## SUMMARY OF NRC/DOE TECHNICAL EXCHANGE ON THE RESULTS OF THE NRC AUDIT REVIEW OF DOE'S TSPA-95

May 22-23, 1996  
U.S. Department of Energy  
Bank of America Building  
101 Convention Center Drive  
Las Vegas, Nevada 89109

On May 22-23, 1996, staff from the U.S. Nuclear Regulatory Commission and the U.S. Department of Energy (DOE) conducted a technical exchange to discuss the results of the recently completed NRC staff audit review of DOE's *1995 Total System Performance Assessment* for a proposed repository at Yucca Mountain, Nevada (hereafter referred to as "TSPA-95"<sup>1</sup>). Representatives from the State of Nevada, affected units of local government, the U.S. Nuclear Waste Technical Review Board (NWTRB), the Advisory Committee on Nuclear Waste, the Electric Power Research Institute, and DOE program participants also attended the technical exchange. The agenda is Attachment 1; Attachment 2 is the list of attendees.

# RESULTS FROM TSPA-95

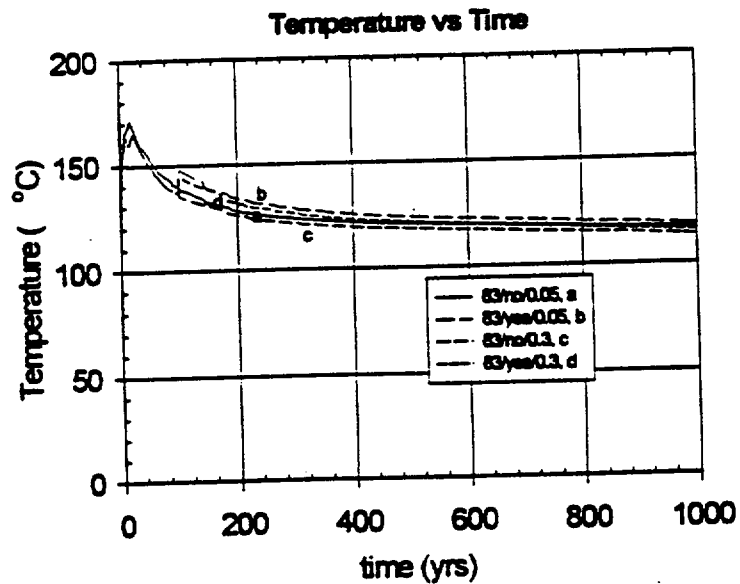
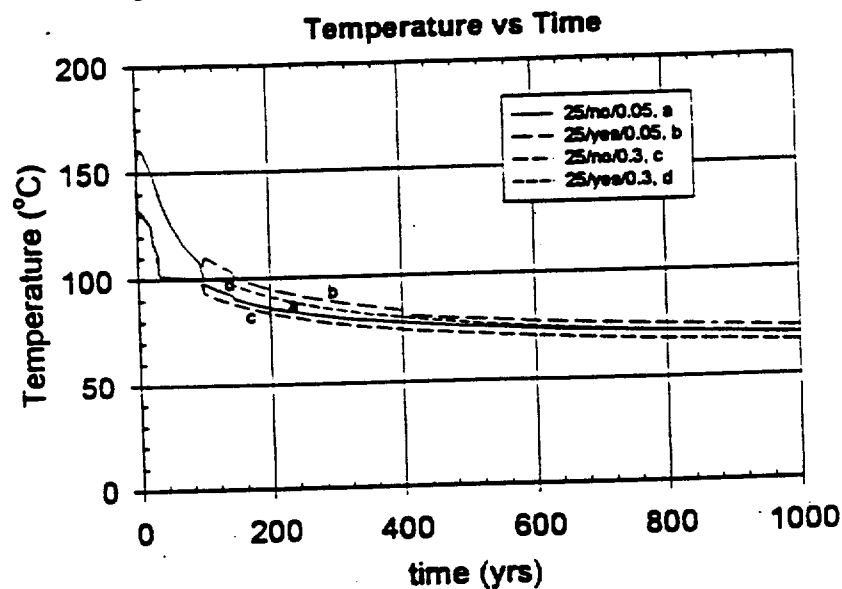
- 2D Drift-Scale Model
- Minimal  $\Delta T$  After Backfilling
- Lower Temperatures Overall

- **TSPA-95 Does Not Explain Differences Between TSPA-93 and TSPA-95**
- **Modeling Approach Is Different From Previous SNL Analysis**
  - **TSPA-93 Uses 3D Drift-Scale Model, Conduction Only**
  - **TSPA-95 Uses 2D Drift-Scale Model, Coupled Heat and Mass Transfer**
- **Predicted Waste Package Temperatures Differ From Previous SNL Analysis**
  - **TSPA-95 Predicts Much Smaller  $\Delta T$  After Backfilling**
  - **TSPA-95 Predicts Lower Temperatures Overall**

# Thermal Embrittlement of Steel Overpack

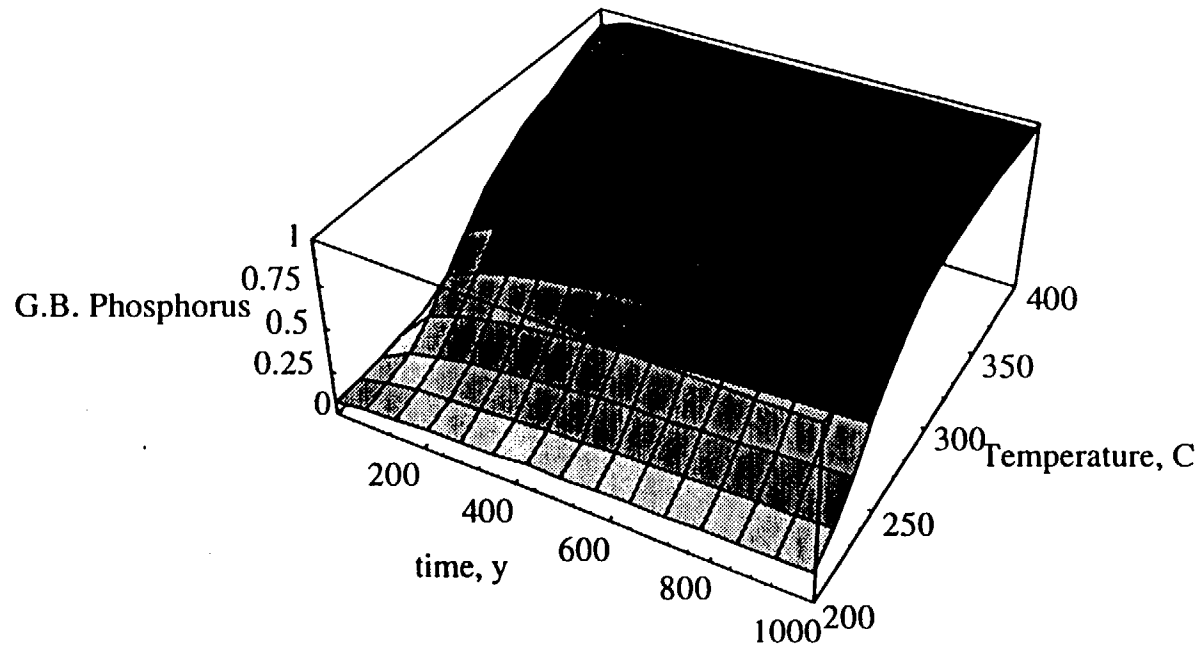
## ☐ Bases for Concern

- ◆ Embrittlement can occur due to P segregation to grain boundaries and residual stress as well as seismic effects
- ◆ Considerations of design for corrosion should be balanced against considerations for embrittlement

## ☐ Points For Consideration

- ◆ Determination of overpack wall temperatures for various AMLs, fuel histories
- ◆ Determination of change in fracture toughness due to thermal aging
- ◆ Determination of residual stresses and acceptable flaw size

## Conditions for Rewetting

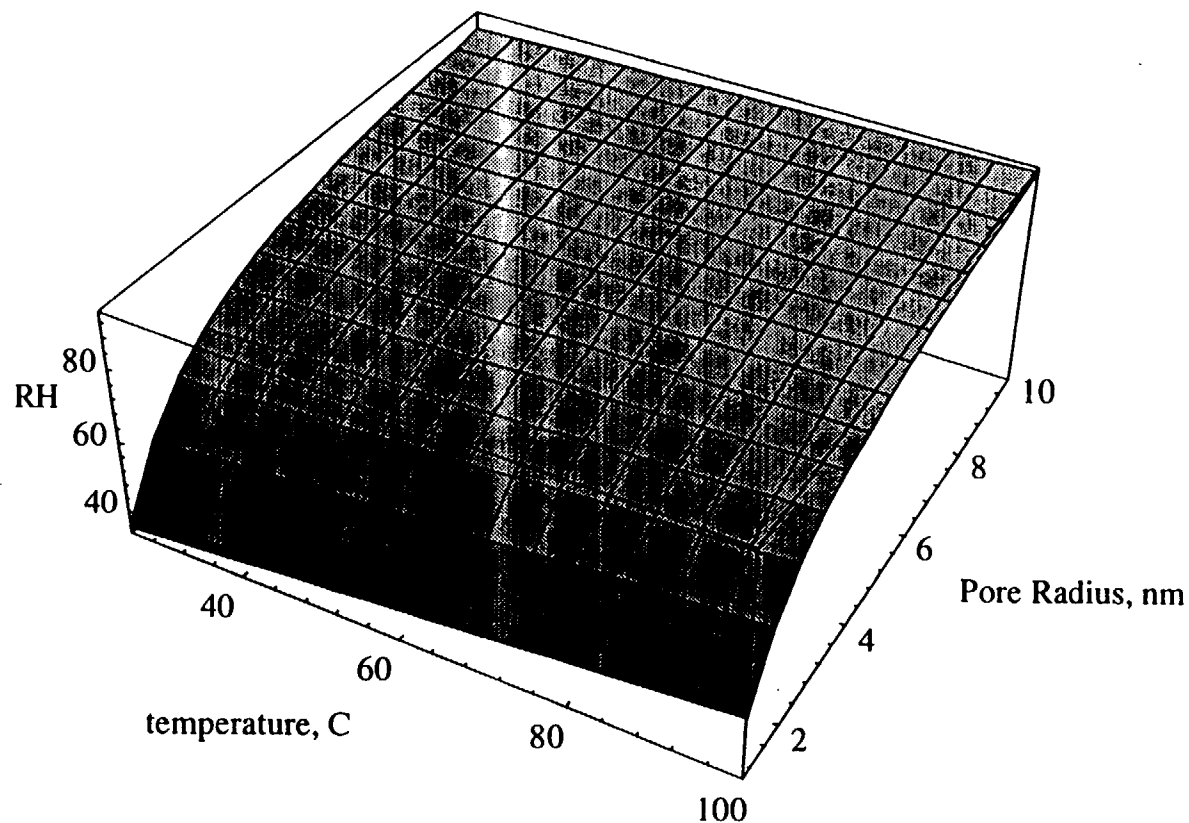
### ☐ Concern

- ◆ The critical RH (70%) in TSPA does not include the effects of chemistry or corrosion/oxidation products on overpack surface
  - ◇ Salt films can lower critical RH to values as low as 33%
  - ◇ Porous oxide scale has been known to affect critical RH

### ☐ Points For Consideration

- ◆ The effects of near-field chemistry on rewetting time
- ◆ Salt film formation affected by back flow of pure water - results of coupled models
- ◆ Mineral precipitation or dissolution effects on fracture flow

## Corrosion in Humid Air

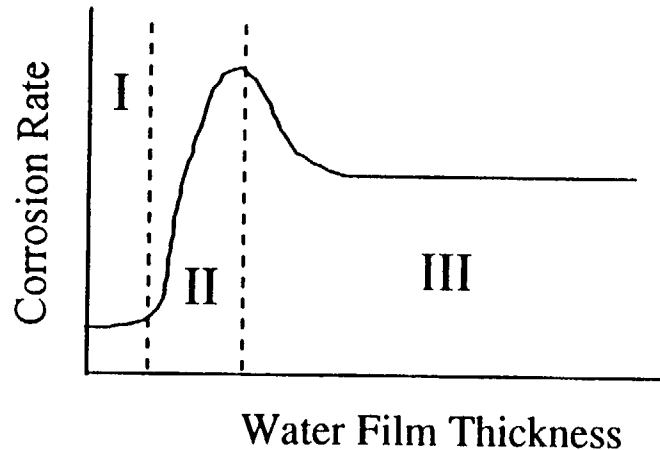
### ☐ Concerns

- ◆ Corrosion in alternate wet and dry conditions not completely determined by the cumulative time above a critical RH
- ◆ Use of parametric equation developed from atmospheric corrosion tests to much higher temperatures and longer time periods may be non-conservative
- ◆ The data used in TSPA-95 are predominantly developed for weathering steels. The atmospheric corrosion rates are highly dependent on the grade of steel
- ◆ There is no mechanistic basis for the approach adopted

### ☐ Points For Consideration

- ◆ Process models for humid air corrosion
- ◆ The data for appropriate materials

## **Pit Penetration Rate Under Aqueous Condition**

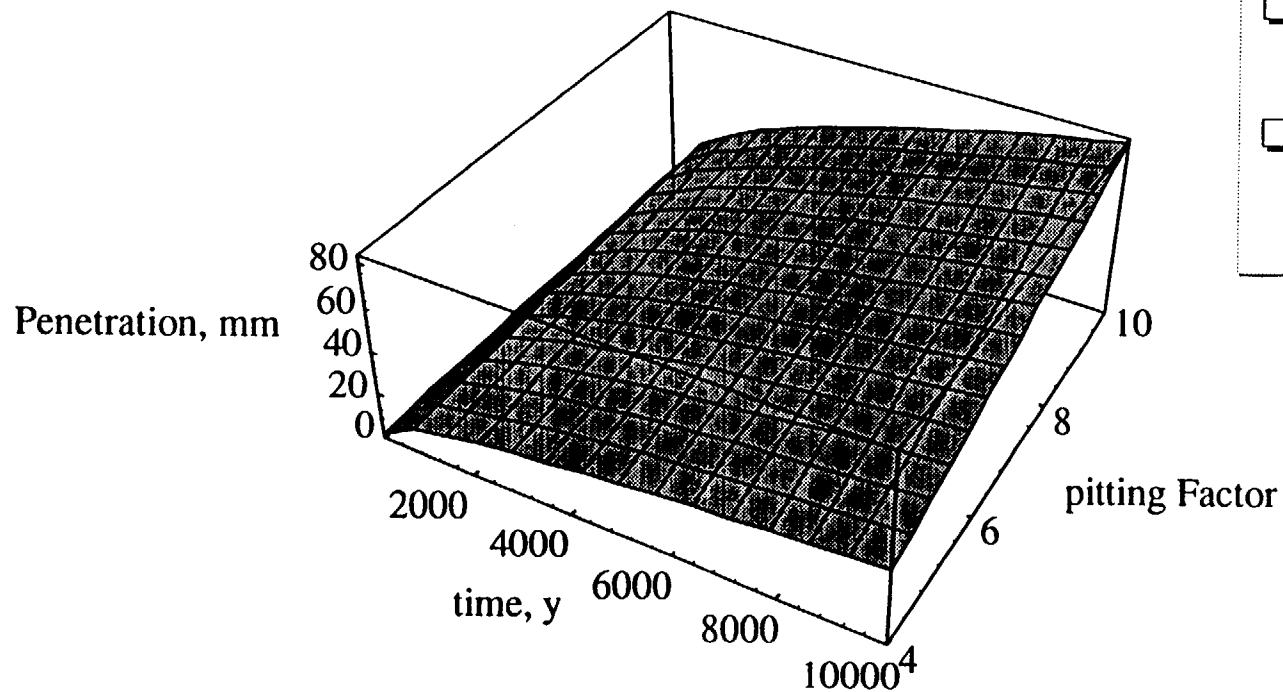
### **❑ Concerns**

- ◆ The pitting factor approach used in TSPA may not be conservative
- ◆ Pitting factor does not consider conditions for initiation of localized corrosion.
- ◆ Most data indicate much higher penetration rates once stable pitting is initiated
- ◆ The effect of potential on pit penetration rate for inner overpack is not considered

### **❑ Points For Consideration**

- ◆ Literature data on pit growth rates
- ◆ Abstraction of stable pit growth models
- ◆ Use of repassivation potential versus pitting potential

# **AUDIT REVIEW OF INFILTRATION PERCOLATION**

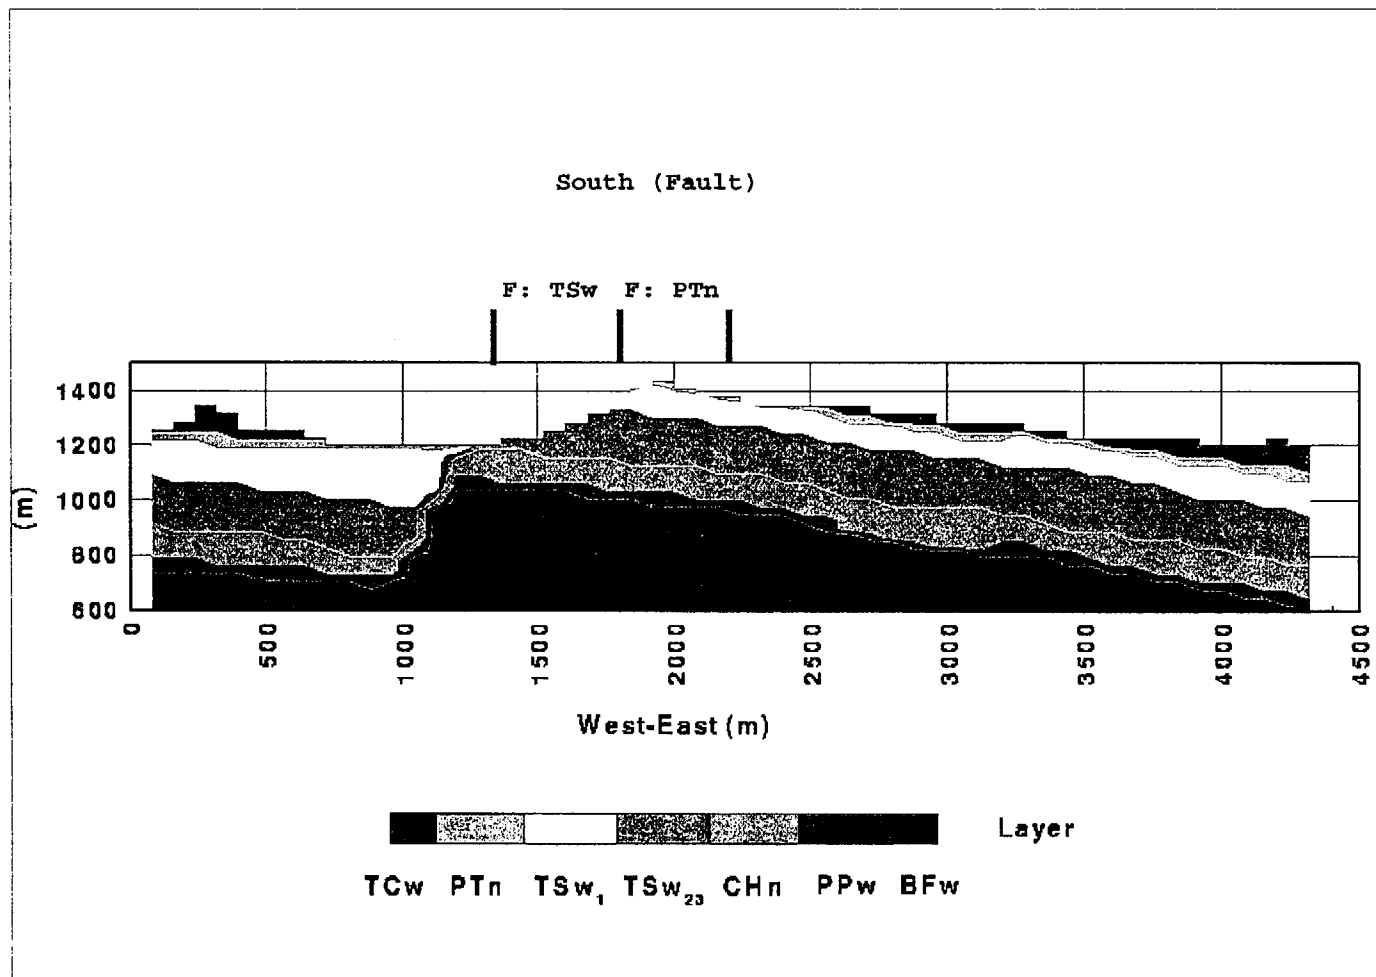
- **TSPA-95 Modeling Approach Did Not Appear To Consider Impact Of Focused Infiltration**
- **Preliminary Analysis Was Conducted To Examine Relationship Between Infiltration And Deep Percolation**
  - **Comparison of focused and distributed infiltration**
  - **Evaluation of lateral diversion effects**
  - **Impact of faults**

Figure 9.3-12 Expected-value dose history for <sup>237</sup>Np. 1,000,000 years, infiltration rate comparison: "high" ( $q_{inf} = 1.25$  mm/yr) versus "low" ( $q_{inf} = 0.03$  mm/yr) infiltration, 83 MTU/acre, backfill, cyclical- $q_{inf}$  climate model.

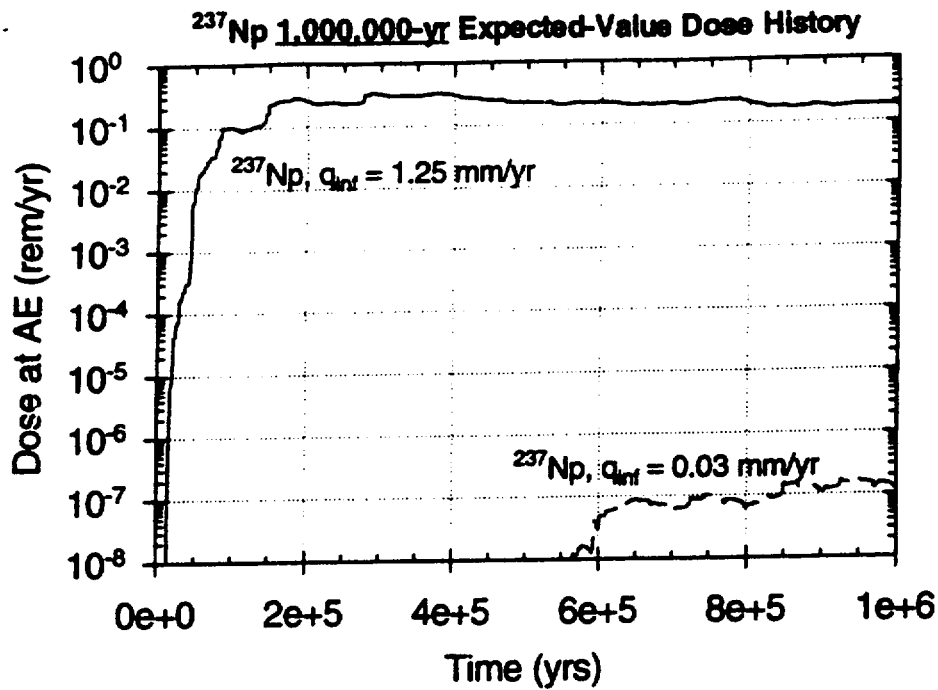
**Figure 9.3-12 shows the Np Concentration in the Aquifer being maintained for over one million years.**

**Random path length abstraction (7.4.4 and 7.4.5) appears to be possible explanation.**
